CITY OF ALBUQUERQUE

RE: **Car Crafters**
5600 Holly Ave NE
Request Permanent C.O. – Accepted
Engineers Stamp Date 1/29/15 (C18D044)
Certification Dated: 3/30/16

February 17, 2016

RE: **Car Crafters**
Grading and Drainage Plan
Engineers Stamp Date 1/12/15 (C18-D044)

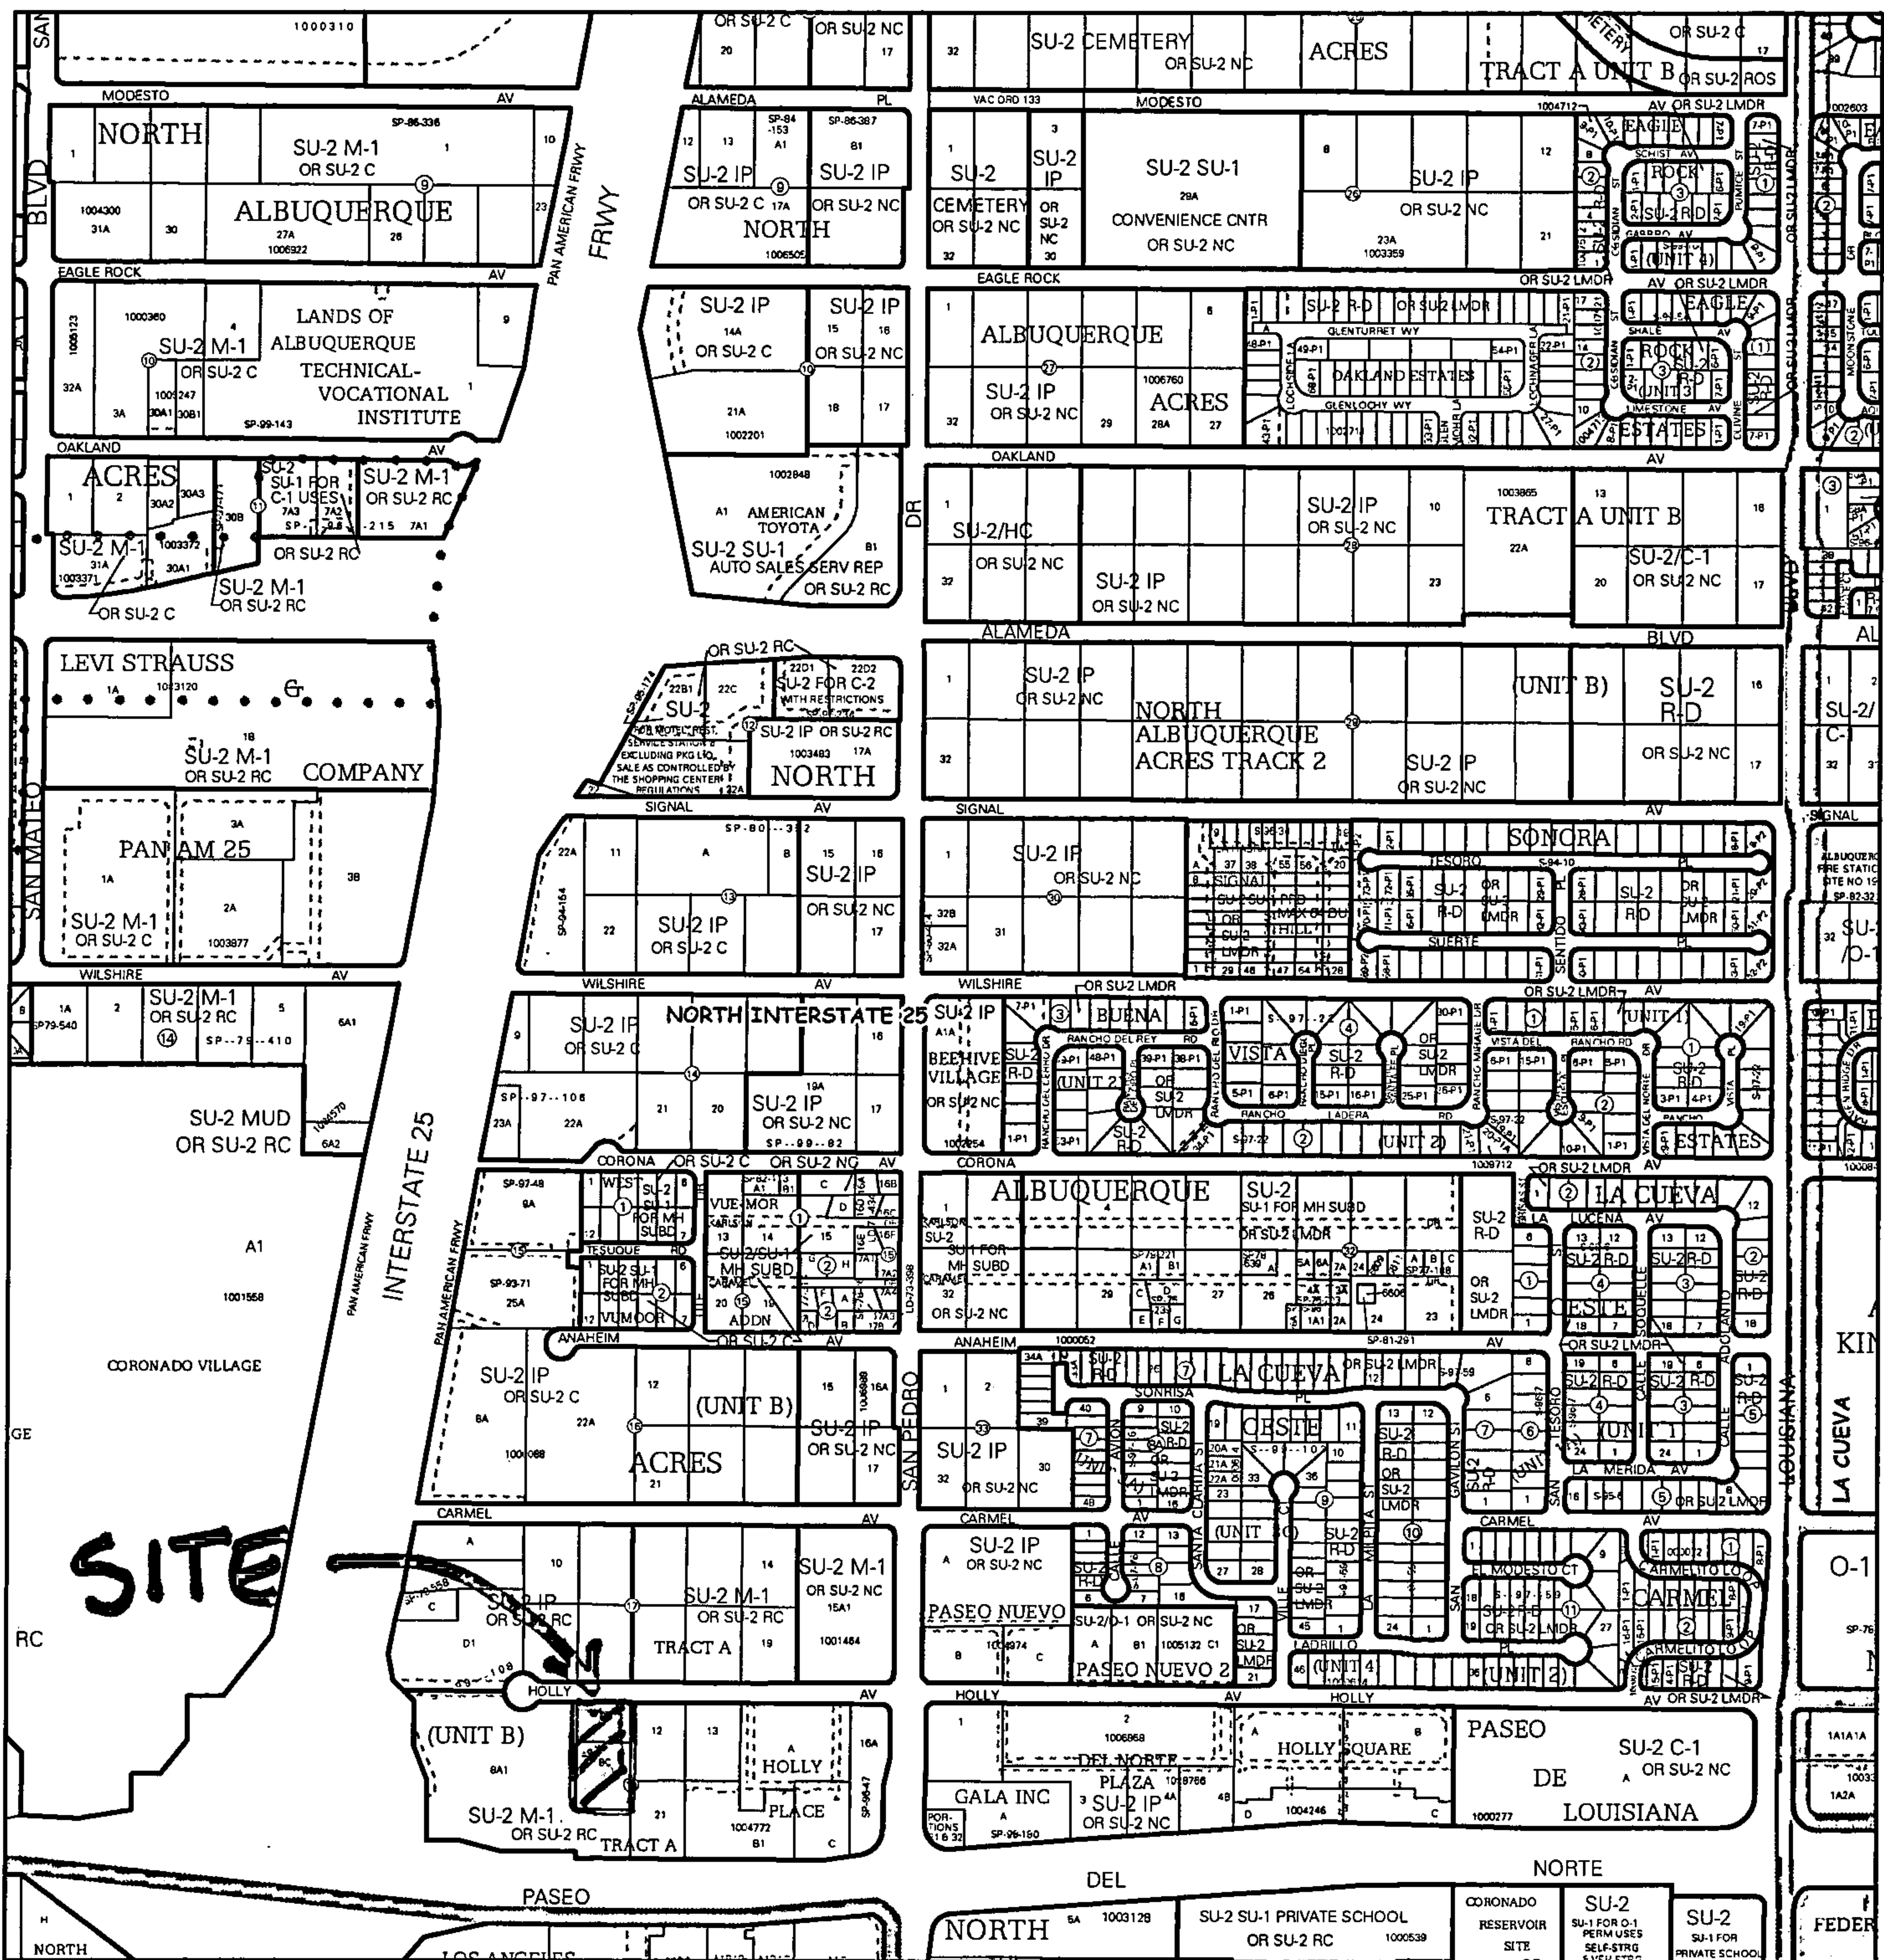
5.67
BUT MS ROAD
OUTFLOW WOULD
BE MISSING
AP 3

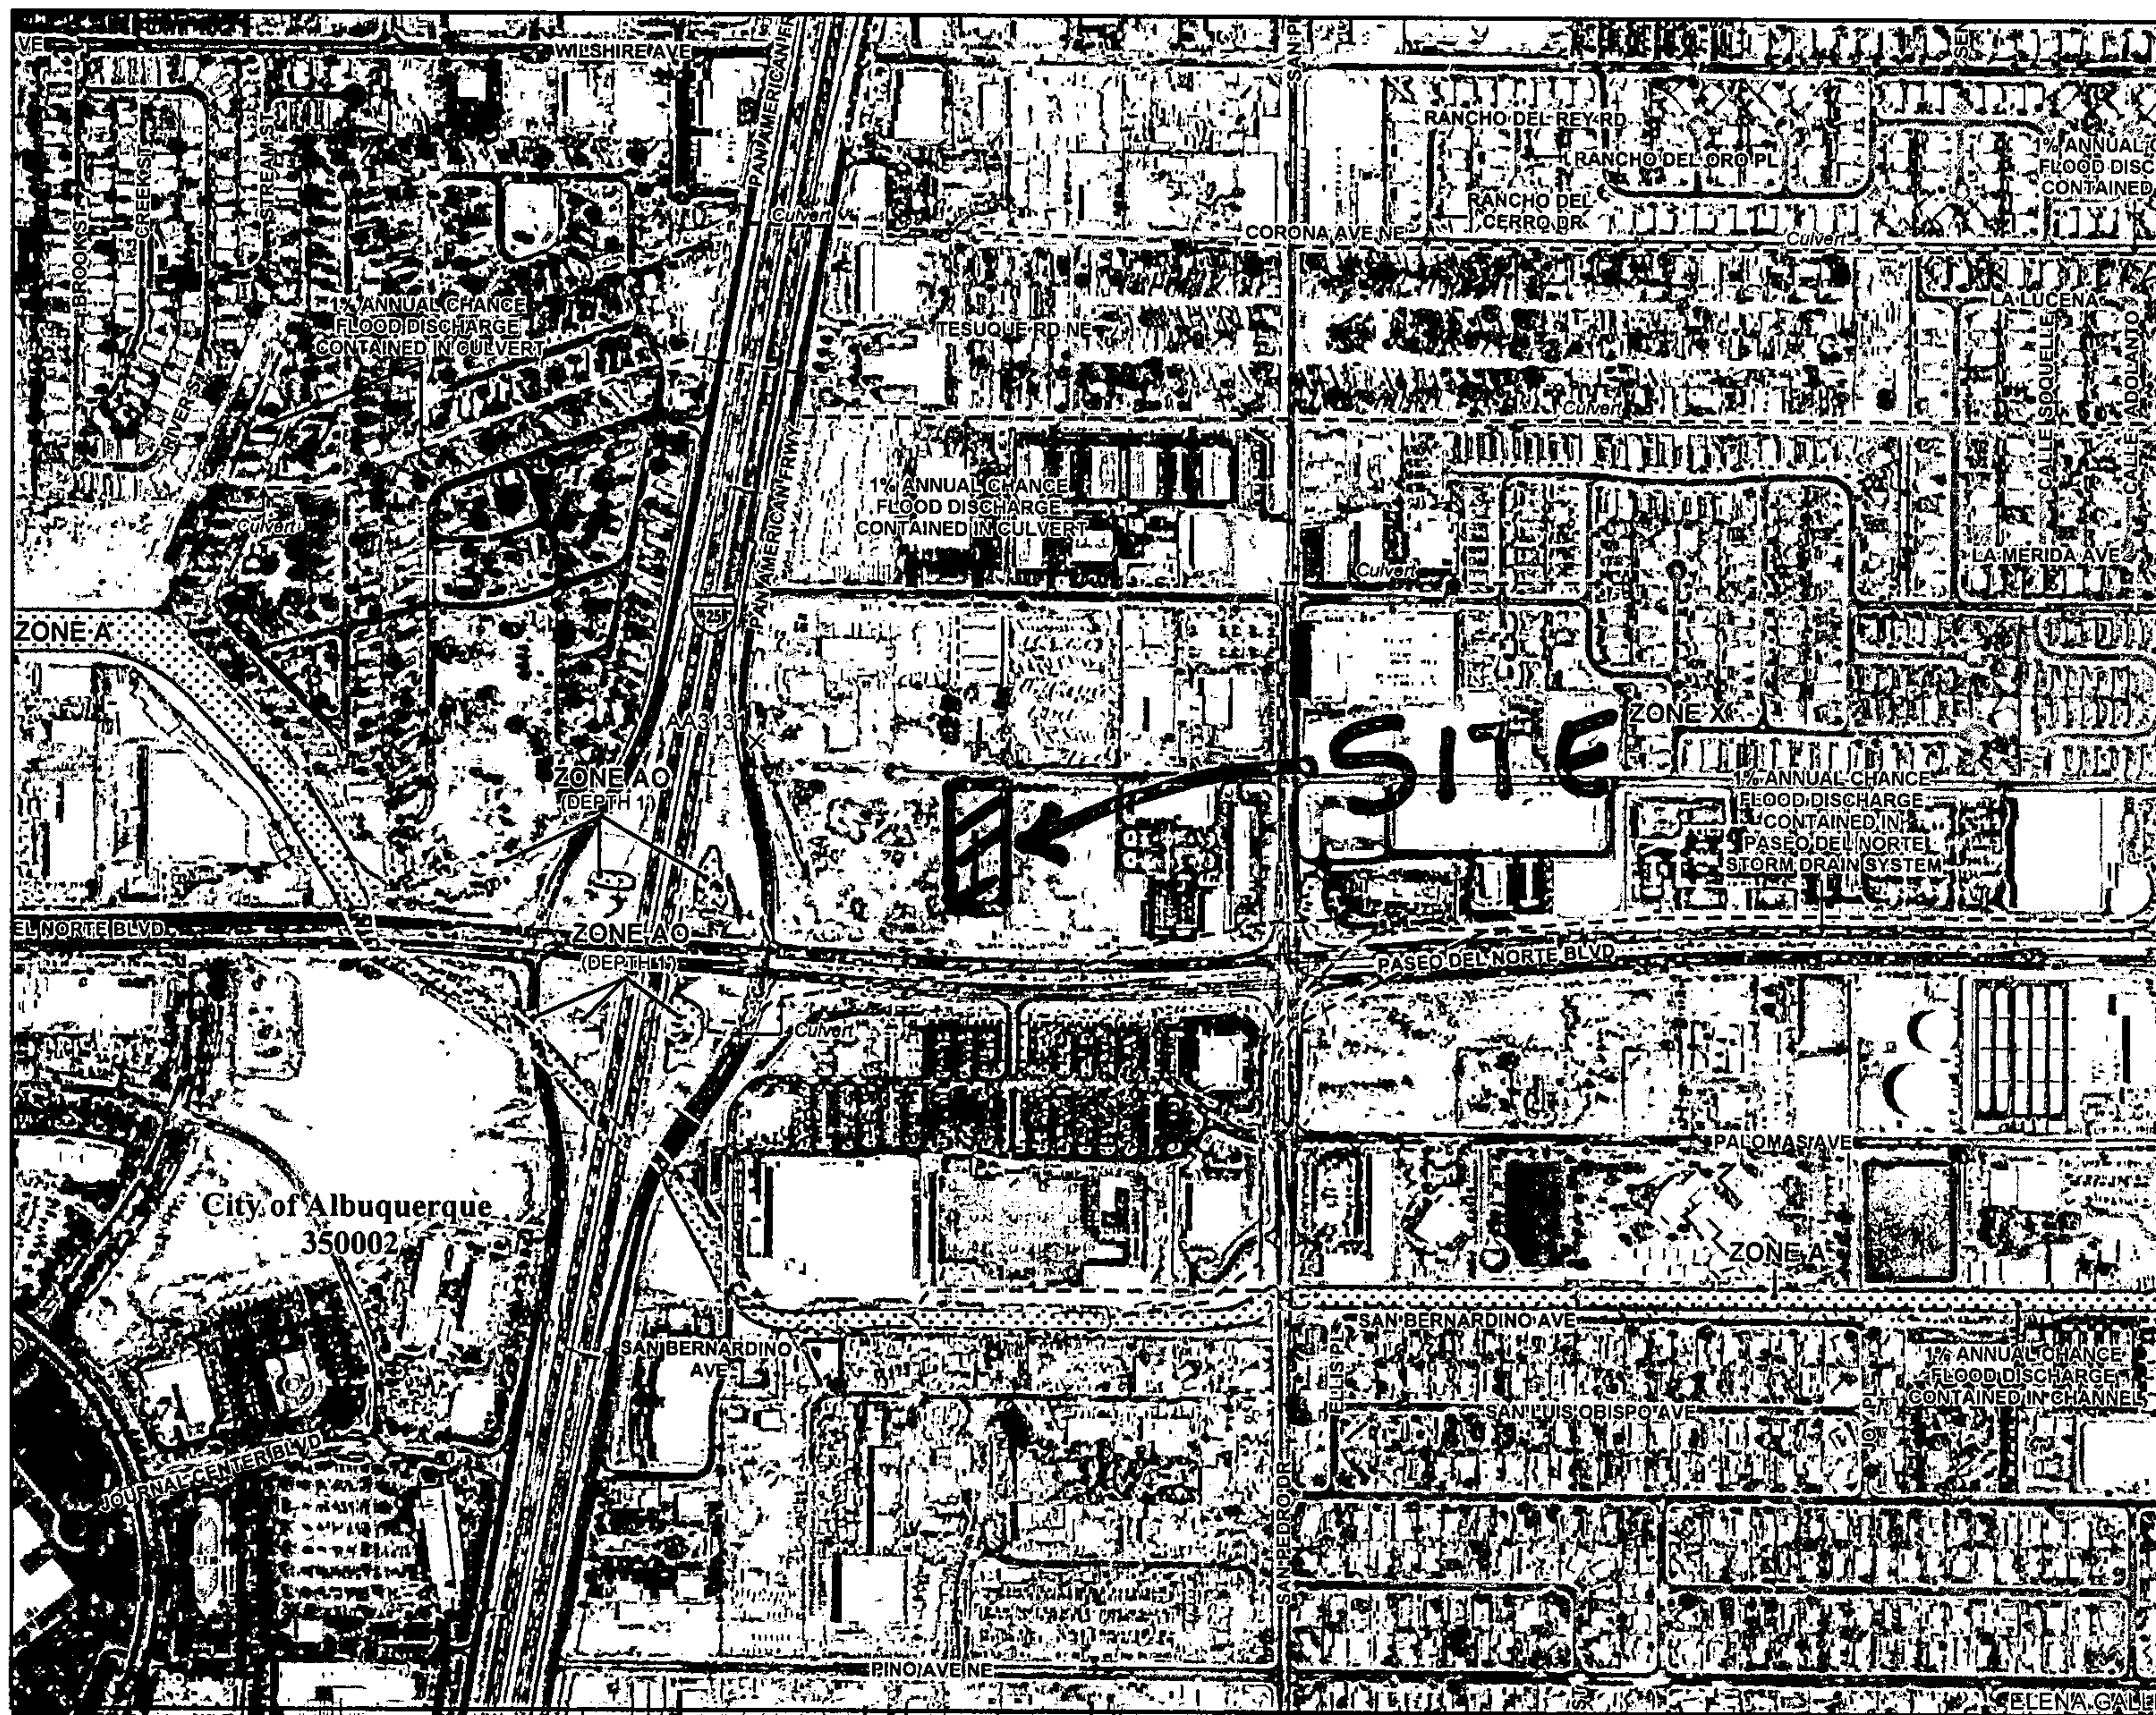
Does not
match
G&D plan
